Proposed Ground Floor Plan

PLANNING NOTES AMENDMENT

Project:	Lower Town House Barn		
	Townhouse Road, Littleborough		
	OL15 9JX		
Title:	Proposed Ground Floor Plan		
Client:	Vernon Wharmby		
Drawn By:	WRS	on	12/08/2024
Original Size:	A2	Project Number:	1017 / 06
Drawing Number:	06 A

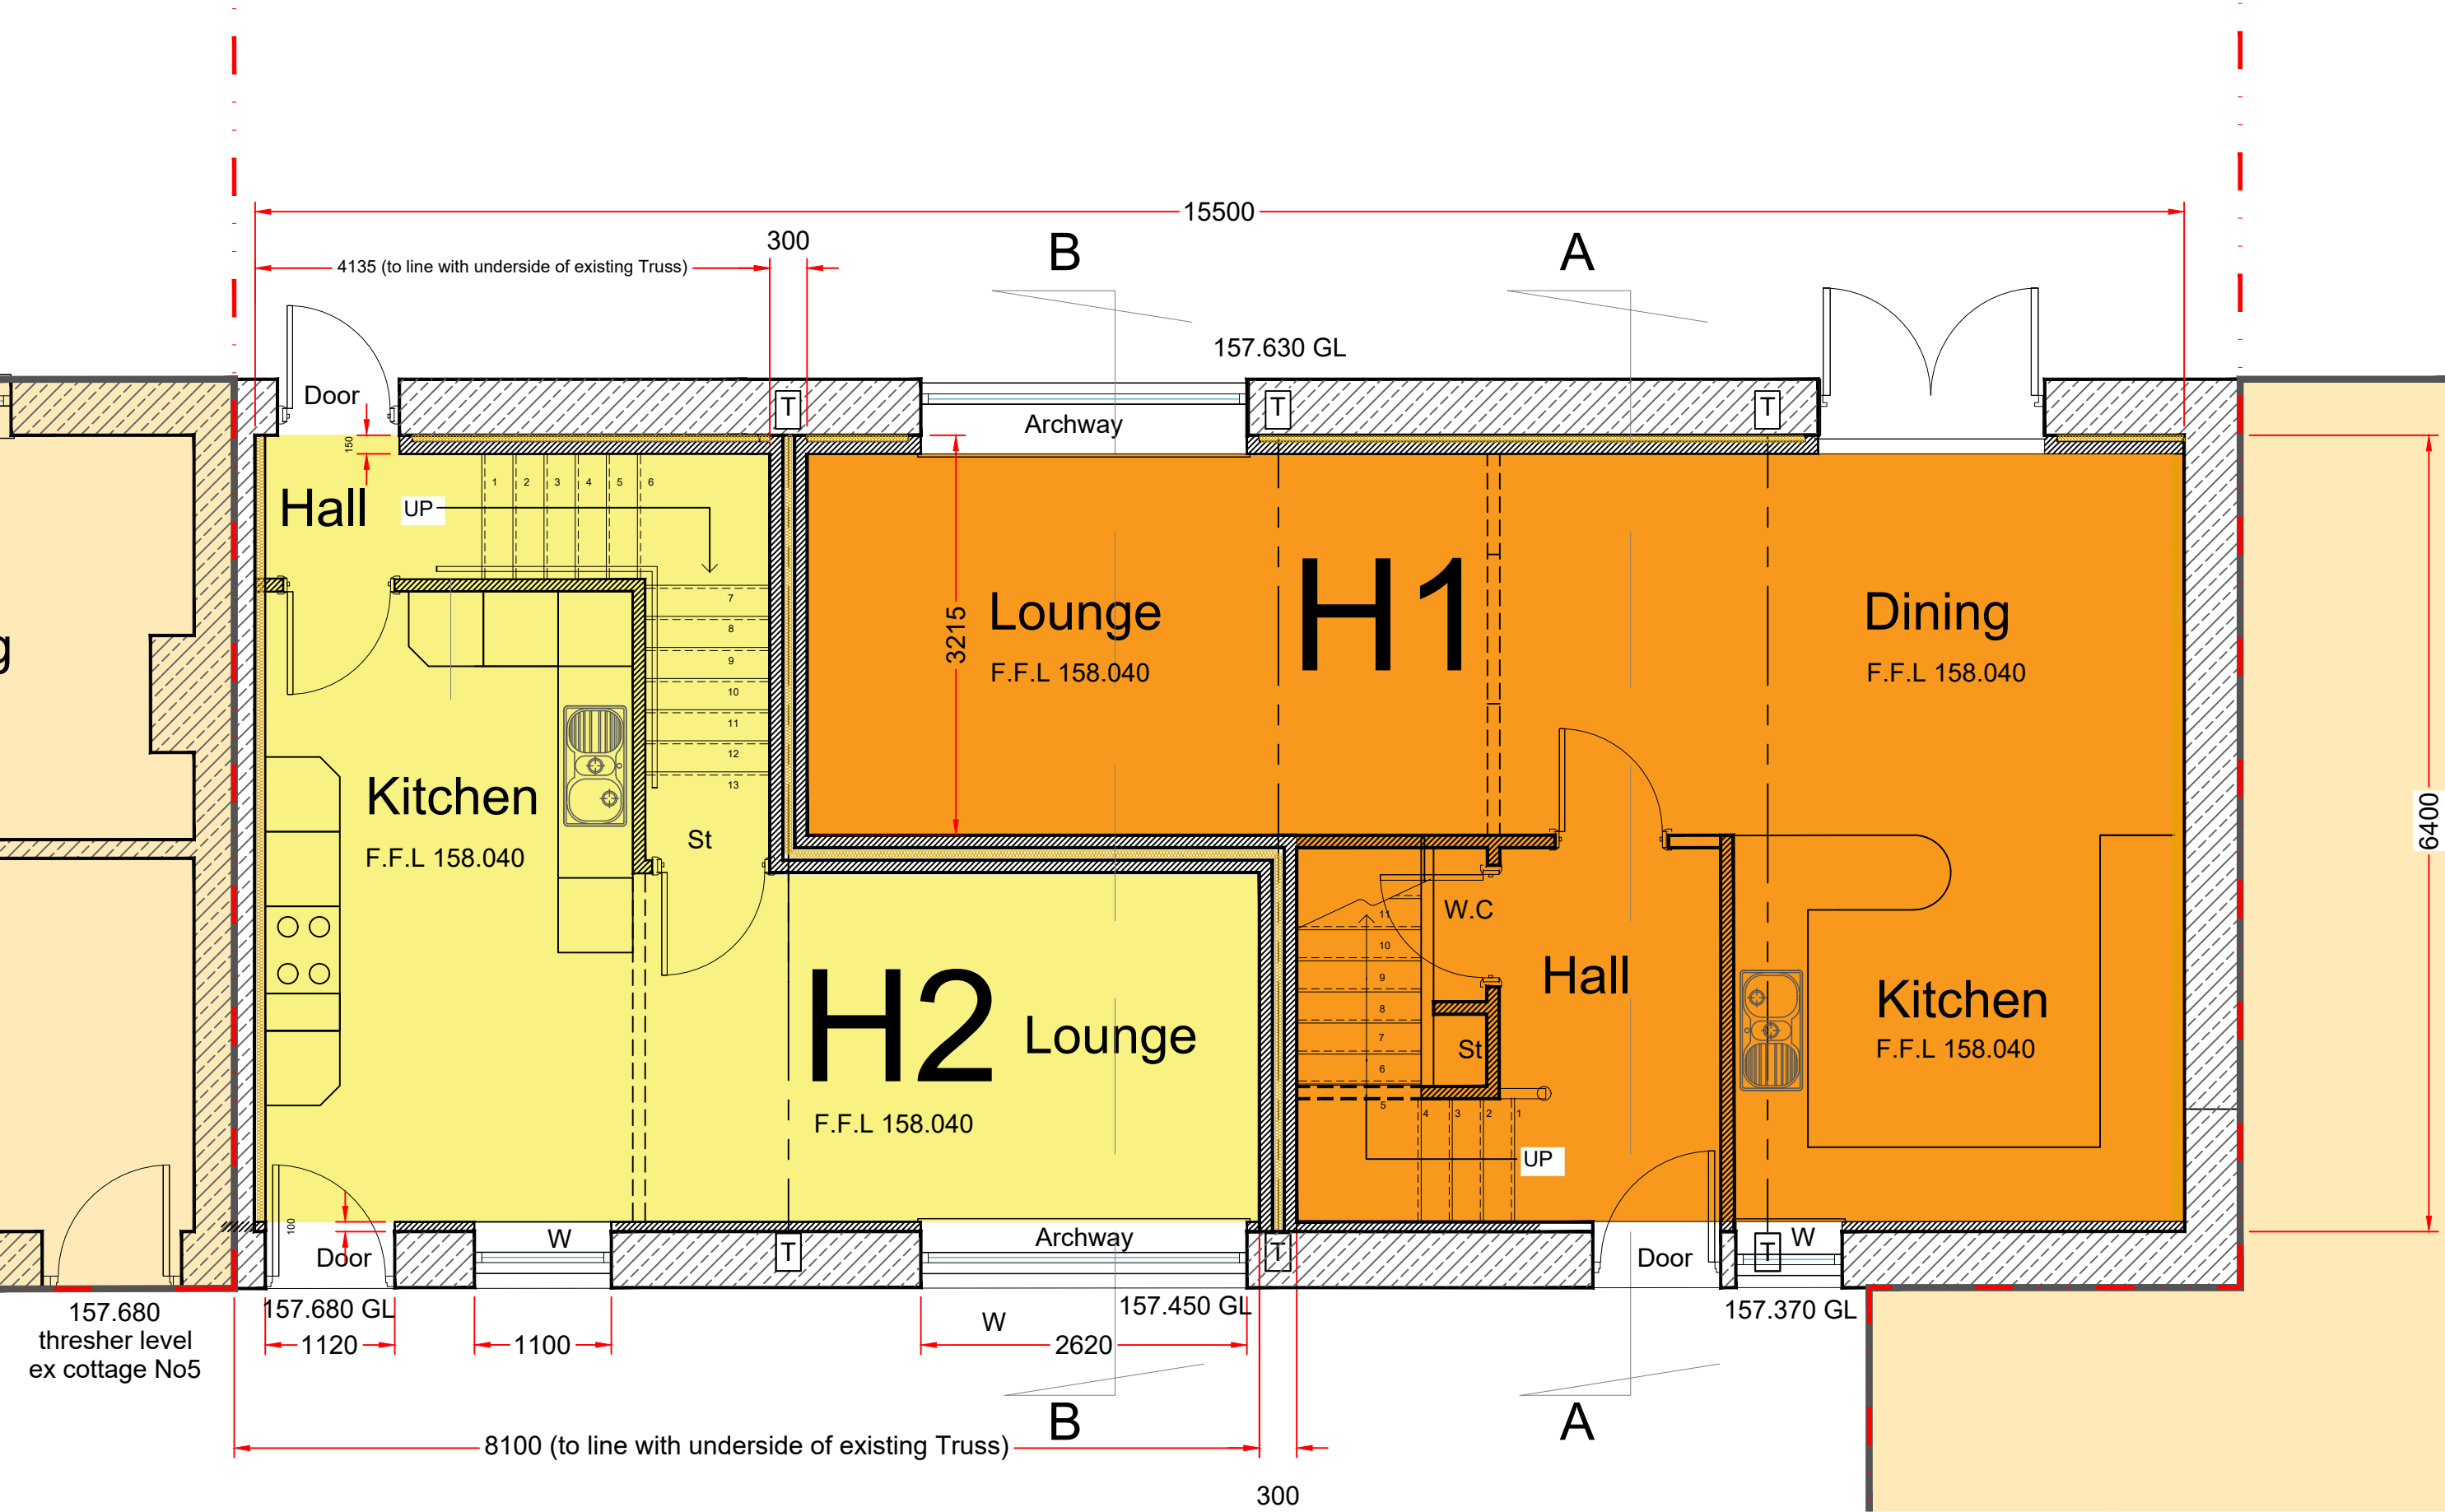
A - 02/11/25 - FFL level raised by 200mm to suit FRA / FFL level = 158.040 and EA requirements

ACO Drainage system incorporated to front & rear building lines - connected into surface water drainage system
